STANDARD DEPARTURE CHART - INSTRUMENT

RJNH / HAMAMATSU

INSTRUMENT APPROACH CHART

SAGRA FIVE DEPARTURE

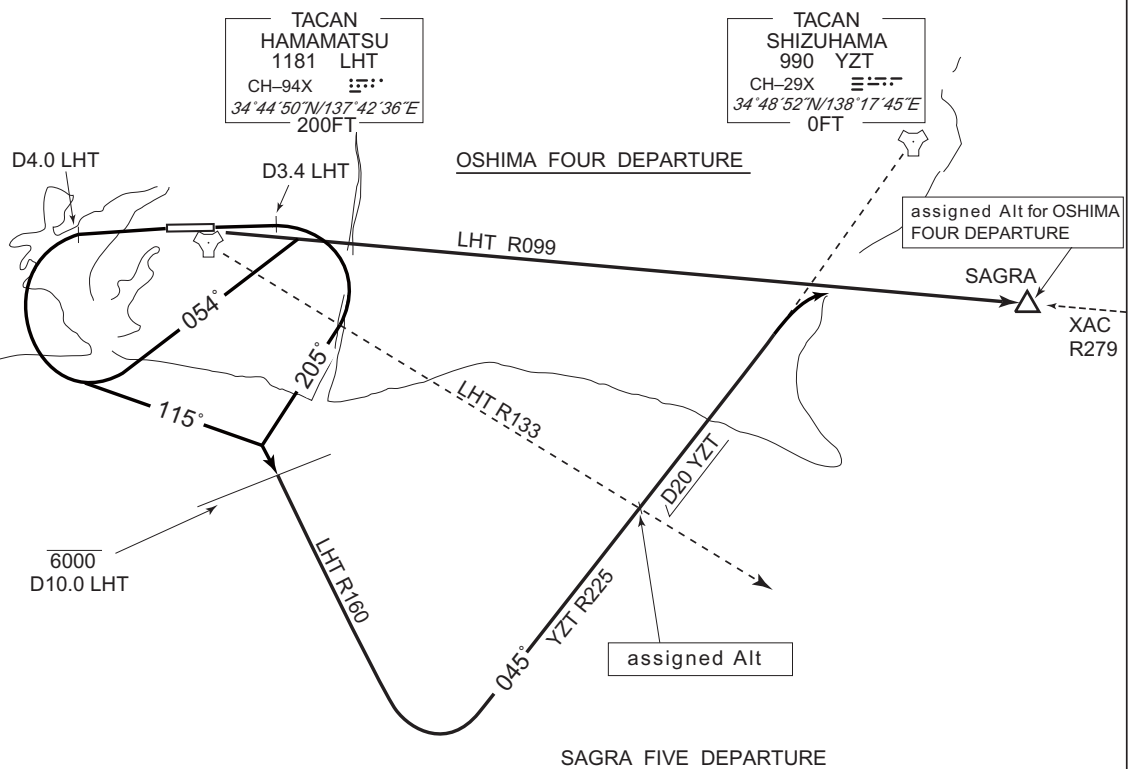
CHANGE : PROC name, PROC course(SAGRA FIVE DEPARTURE, OSHIMA FOUR DEPARTURE). Note deleted(SAGRA FIVE DEPARTURE, OSHIMA FOUR DEPARTURE).

ATSUMI FIVE DEPARTURE

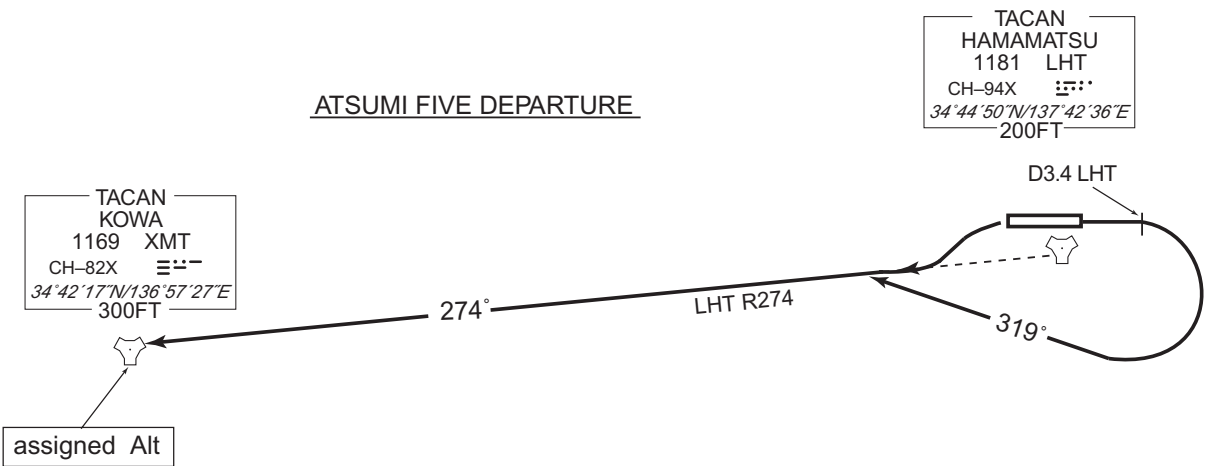
CHANGE : PROC renamed. PROC course. Note deleted.

HAMAMATSU REVERSAL THREE DEPARTURE

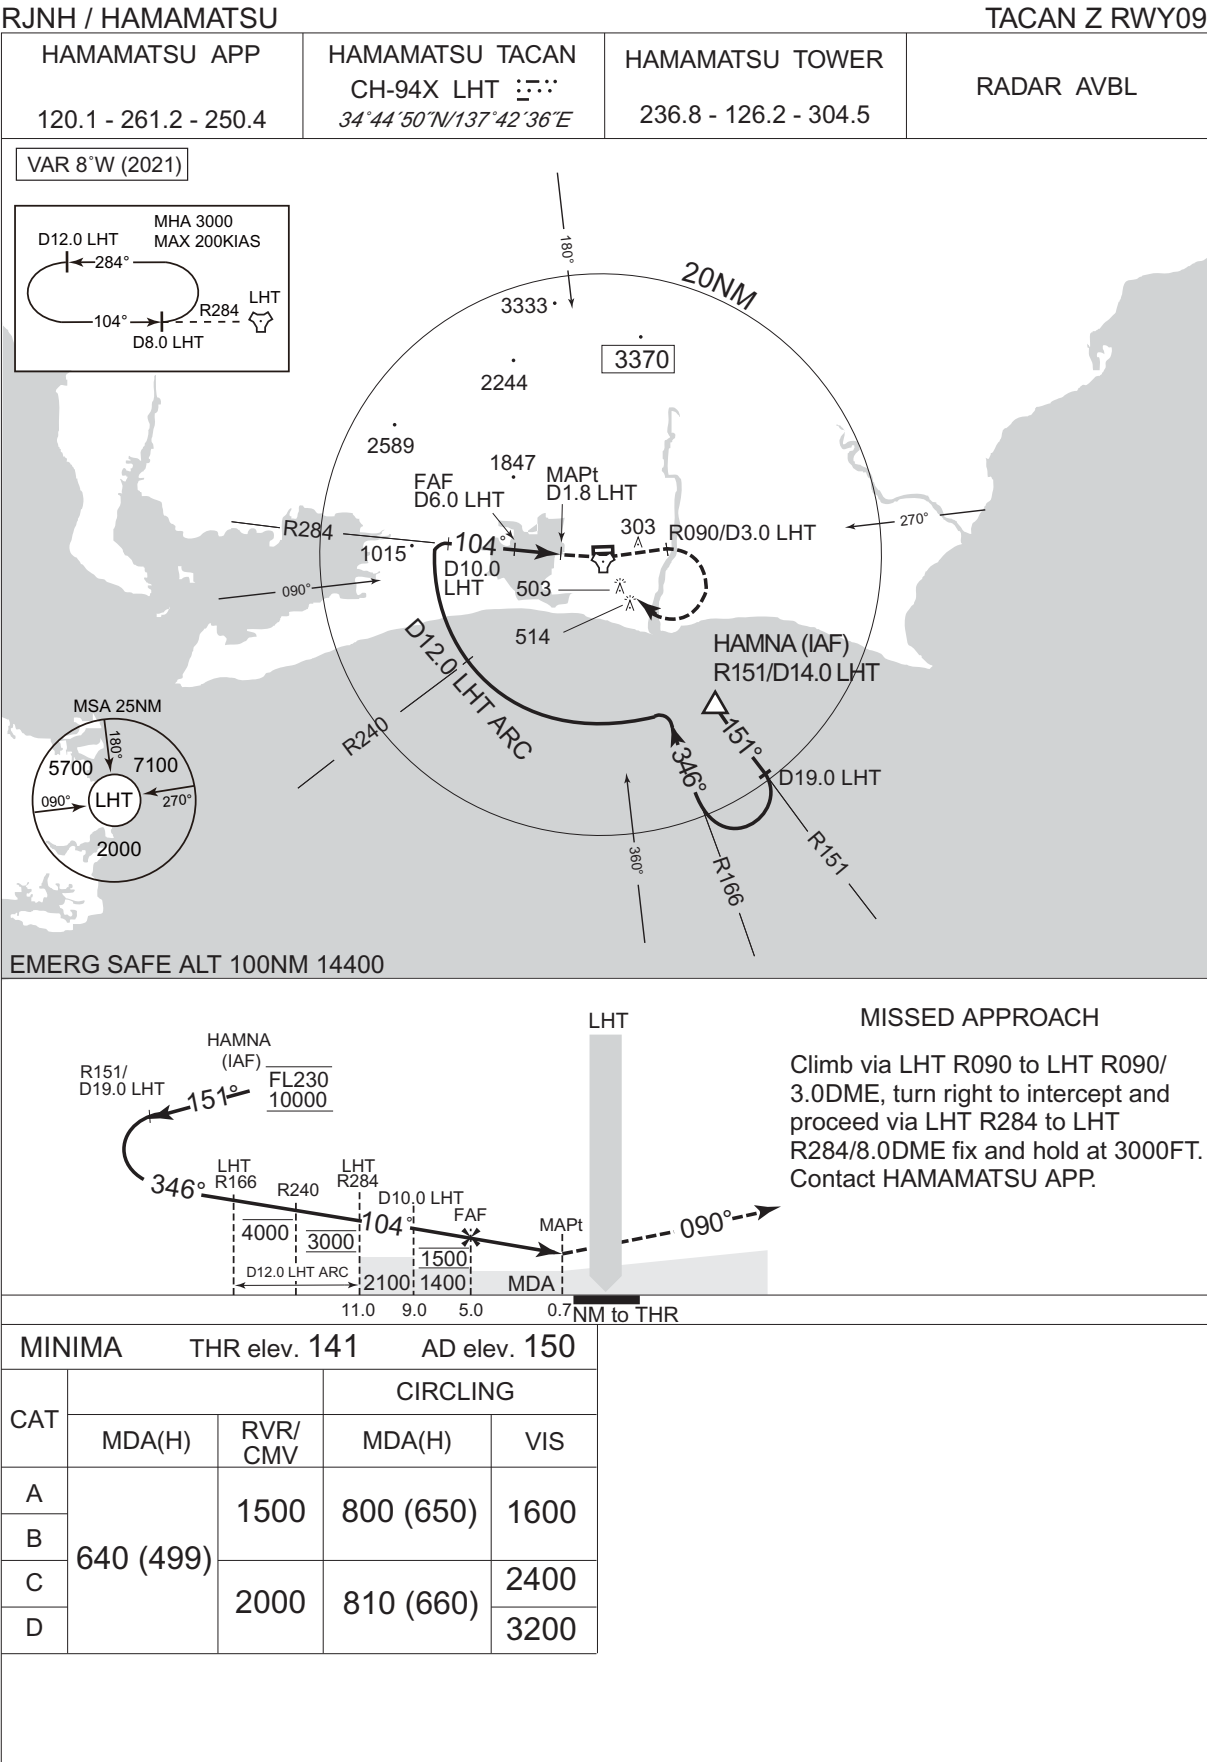
CHANGE : PROC renamed. PROC course. Note deleted.

TACAN Y RWY09

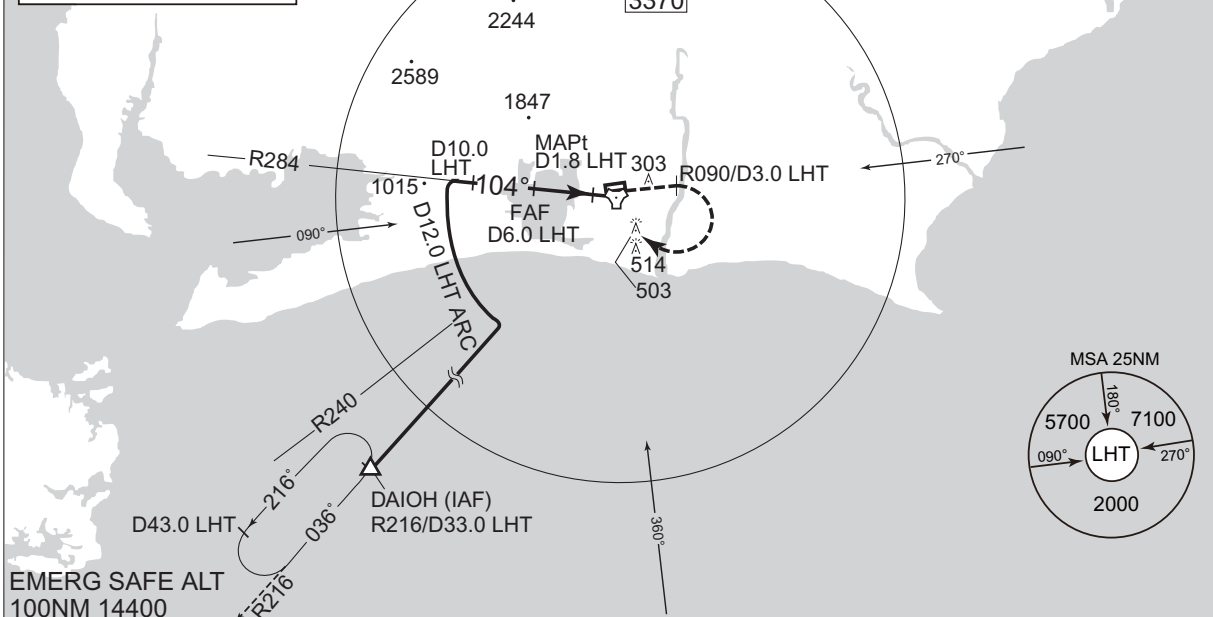
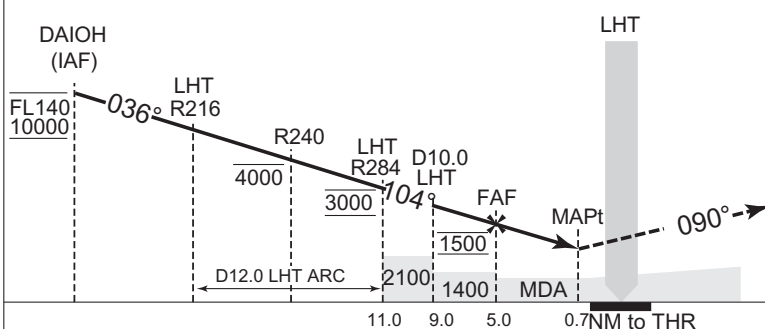
CHANGE : VAR. PROC renamed. PROC course. Description of FAF, MAPt added. MSA. HLDG pattern added. OBST added(HGT 303).
OBST deleted(HGT 410, 504). MISSED APPROACH course. OCA/H added. MDA(H). MDA(H) for CIRCLING.

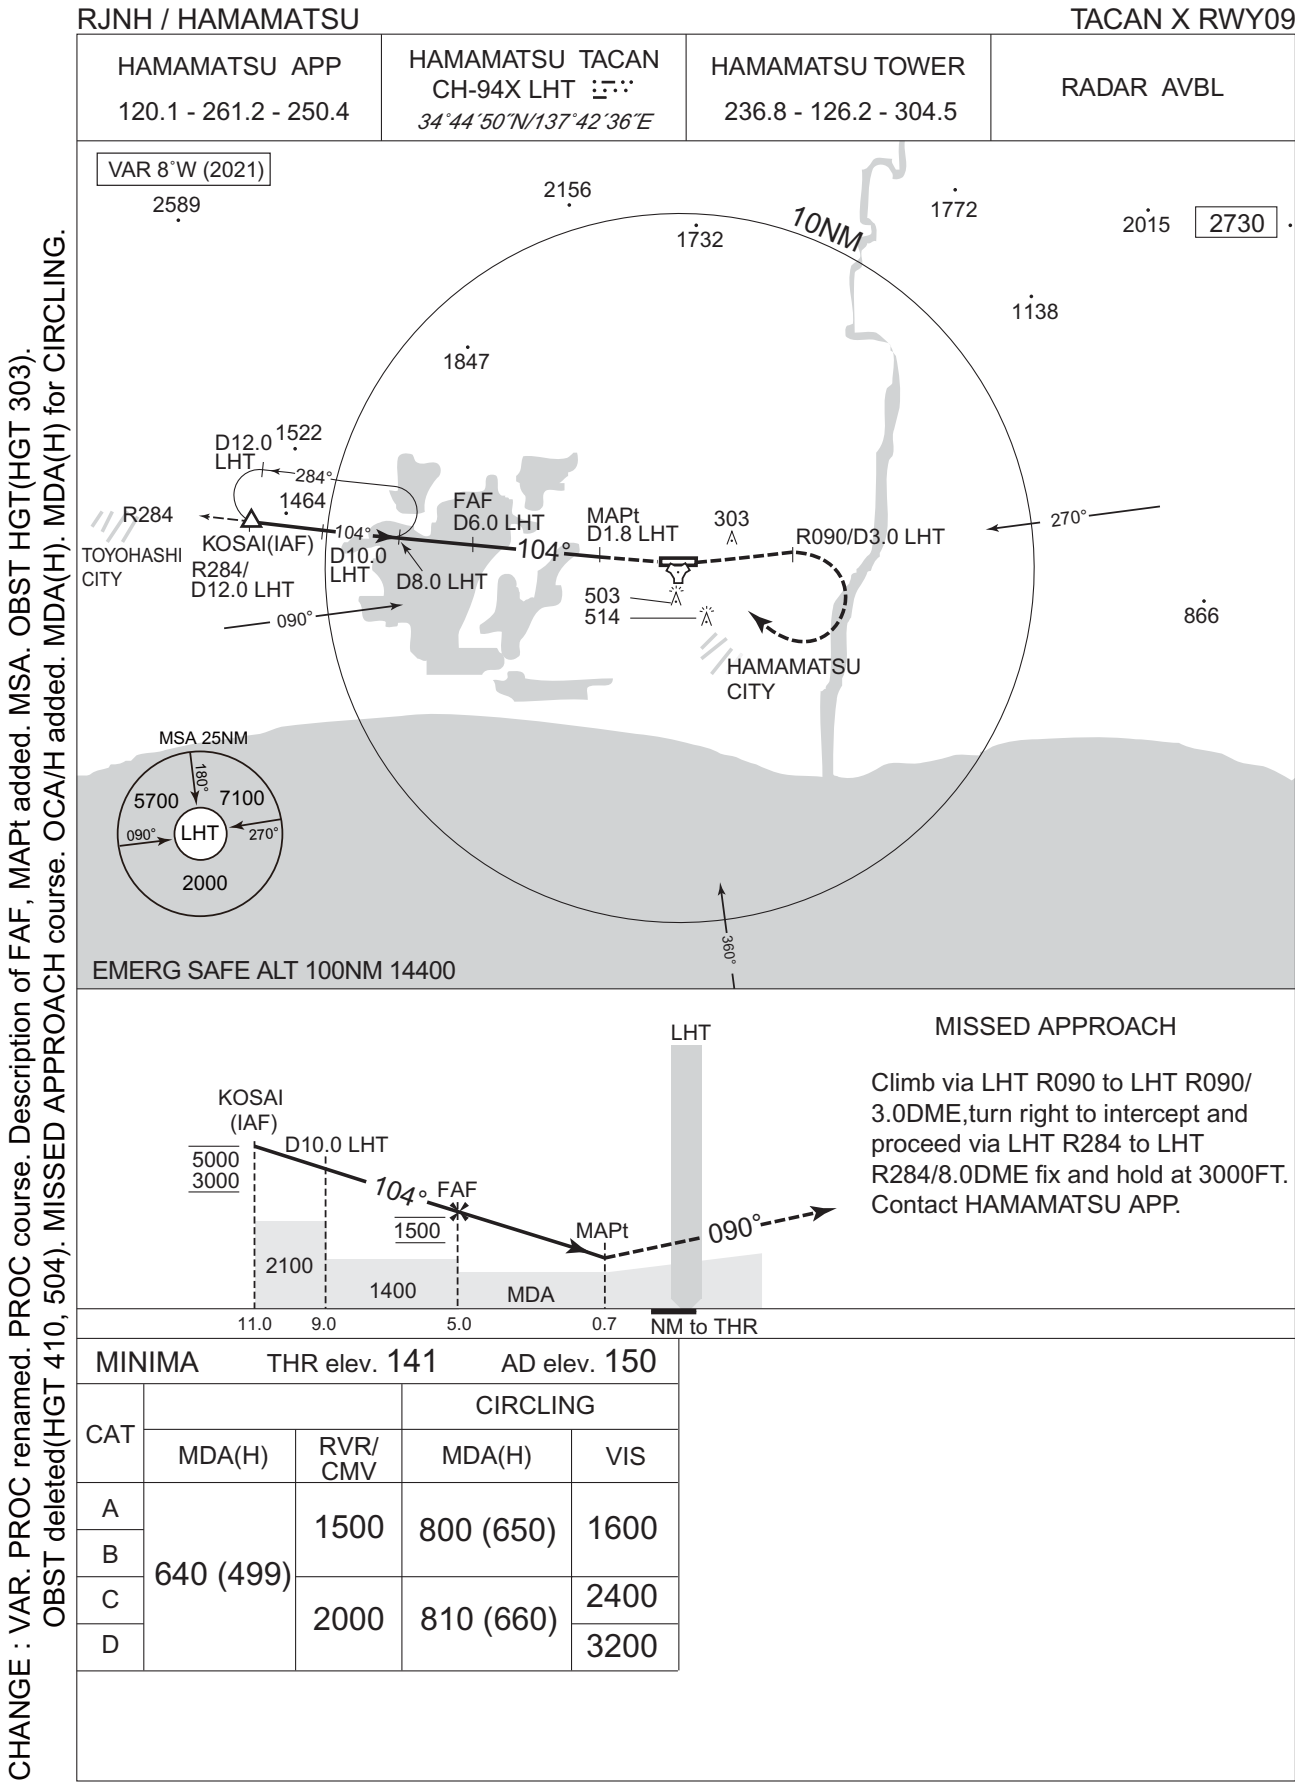
CHANGE : VAR. PROC renamed. PROC course. Description of FAF, MAPt added. OBST added(HGT 303).
OBST deleted(HGT 410, 504). MISSED APPROACH course. ALT restriction(DAIOH). OCA/H added. MDA(H) for CIRCLING.

TACAN Z RWY27

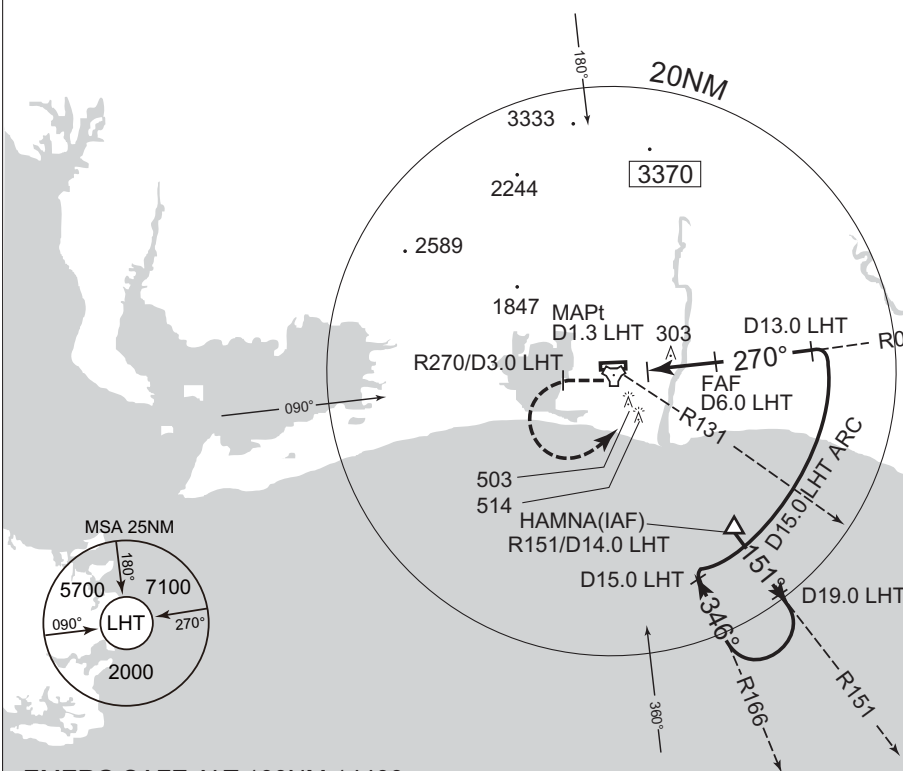
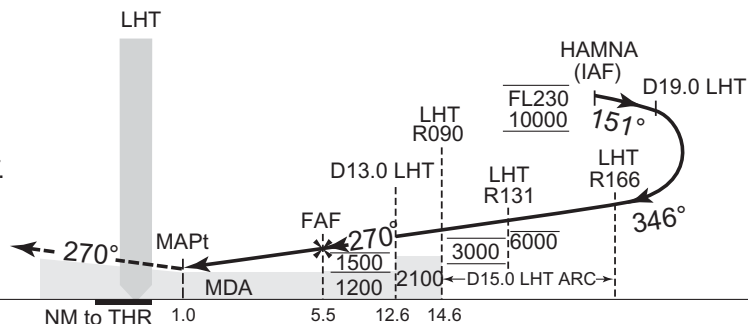
CHANGE : VAR. PROC renamed. PROC course. Description of FAF, MAPt added. OBST added(HGT 303).
OBST deleted(HGT 410, 504). MISSED APPROACH course. ALT restriction(LHT R090). OCA/H added. MDA(H). MDA(H) for CIRCLING.

TACAN Y RWY27

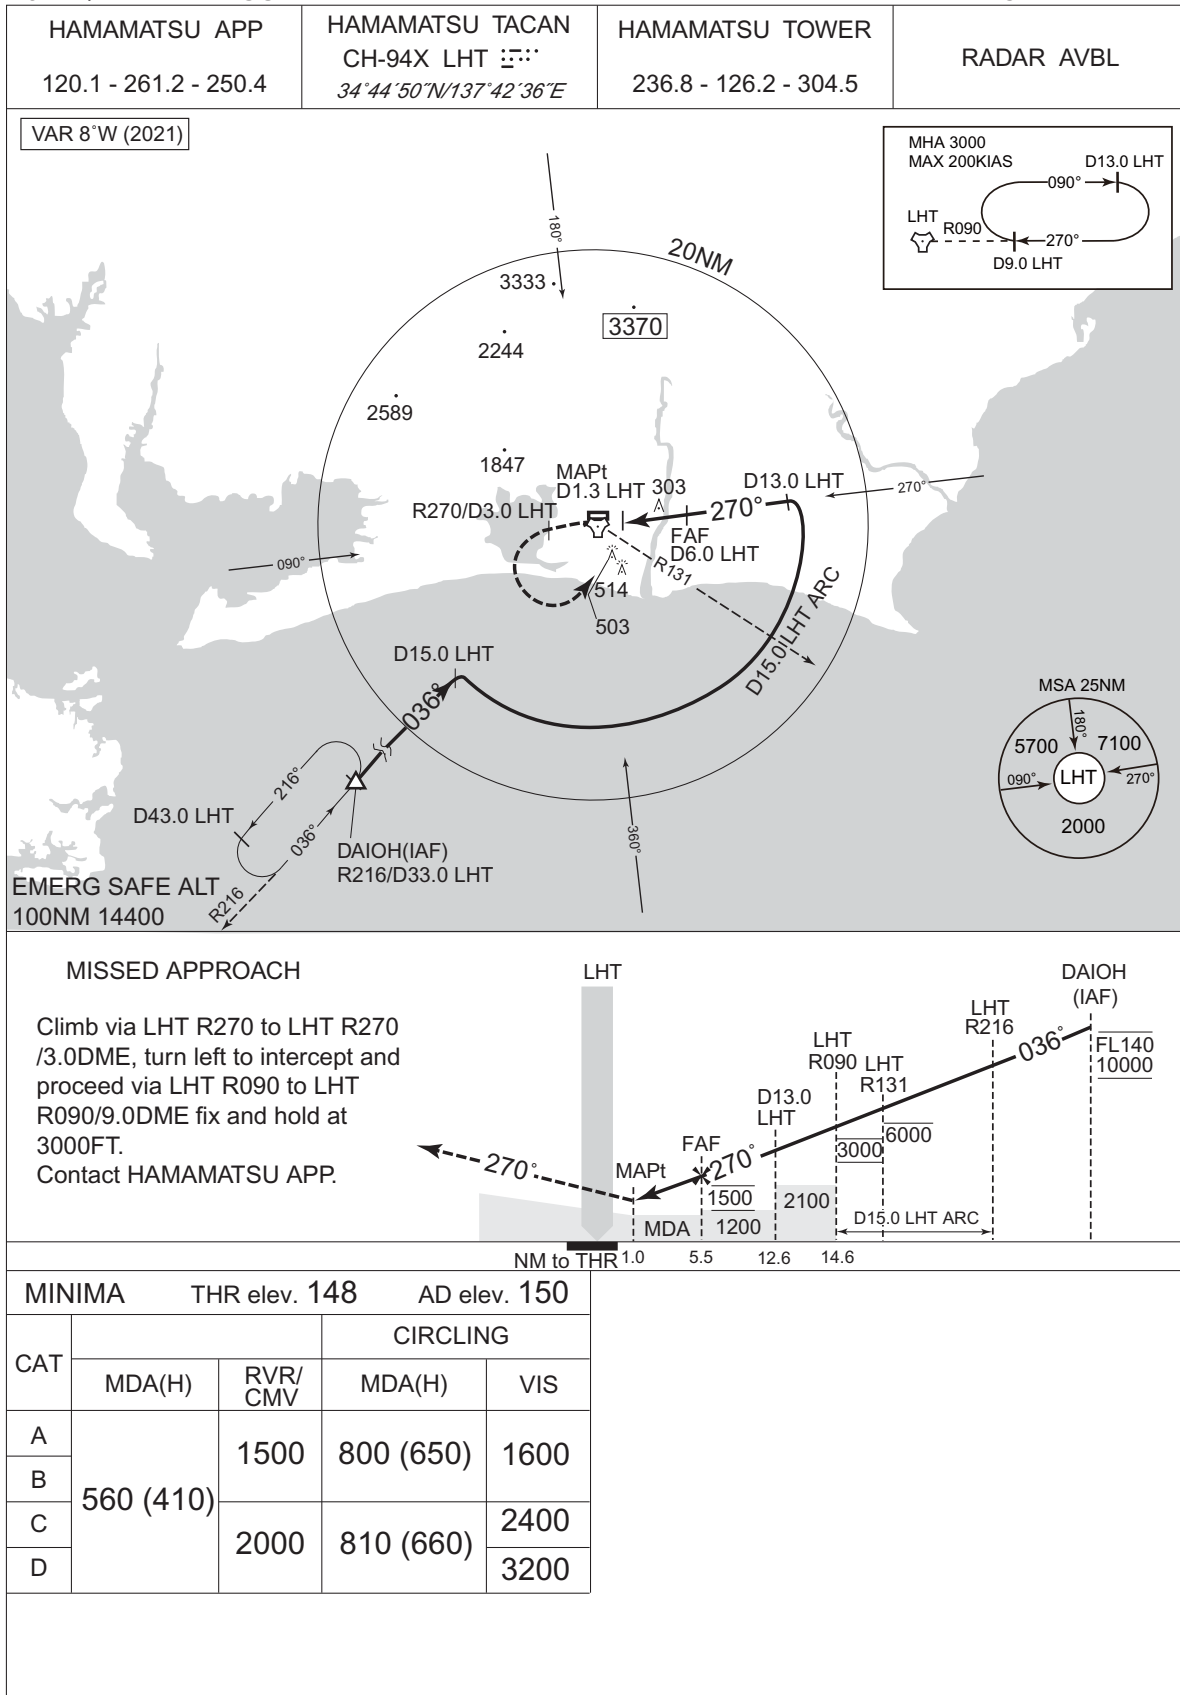
CHANGE : VAR. PROC renamed. PROC course. Description of FAF, MAPt added. MSA. HLDG pattern added. OBST added(HGT 303). OBST deleted(HGT 410, 504). MISSED APPROACH course. ALT restriction(DAIOH, LHT R090). OCA/H added. MDA(H). MDA(H) for CIRCLING.
